California Department of Transportation

11-SD-67

Palisade Santee Commerce Center
FEIR/SCH#2023090144

Thank you for including the California Department of Transportation (Caltrans) in the review of the Final Environmental Impact Report (FEIR) for the Palisade Santee Commerce Center located at 10990 North Woodside Avenue near State Route 67 (SR-67) in Santee.

FIGURE RTC-1

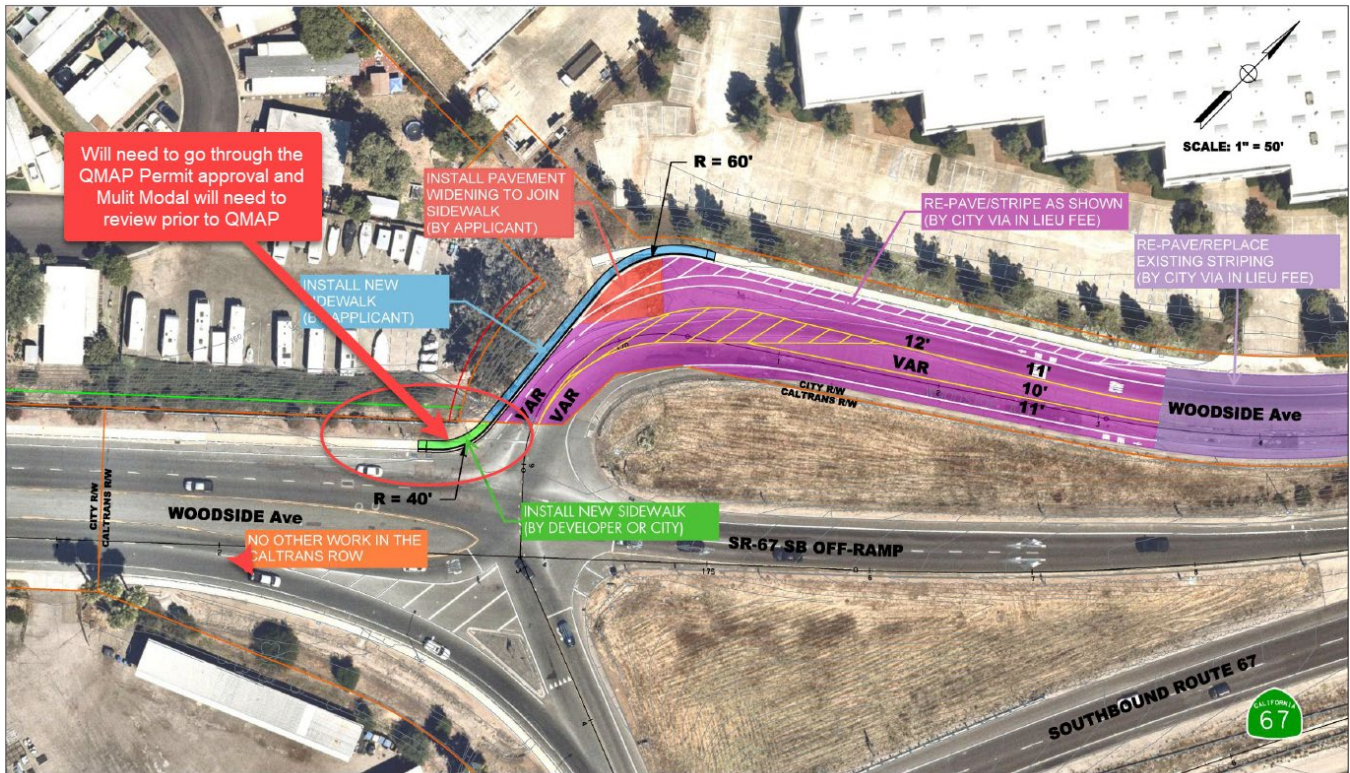
- The latest updated intersection Improvement exhibit Figure RTC-1 has removed the previously proposed roadway widening of North Woodside Avenue approach leg to the SR-67 off-ramp intersection.

- There are still sidewalk improvements being proposed on Caltrans' R/W. This will require an Encroachment Permit through the Quality Management Assessment Process (QMAP).

- There are also bike lanes that can be improved.
 - This proposed project needs to follow Caltrans Design Information Bulletin 94 (DIB-94), "is to be used in conjunction with the Complete Streets Decision Document (CSDD) when making decisions to maximize the use of the public R/W to achieve sustainable and equitable mobility. DIB-94 and the CSDD will help to accomplish the State Highway System Management Plan performance objectives for Complete Streets projects and bicycle and pedestrian facilities."

- A revised TIS has not been provided to Caltrans by the developer to verify the impacts due to the change in scope of the project which previously showed widening of North Woodside Avenue approach leg to the SR-67 SB off-ramp Intersection which now has changed.
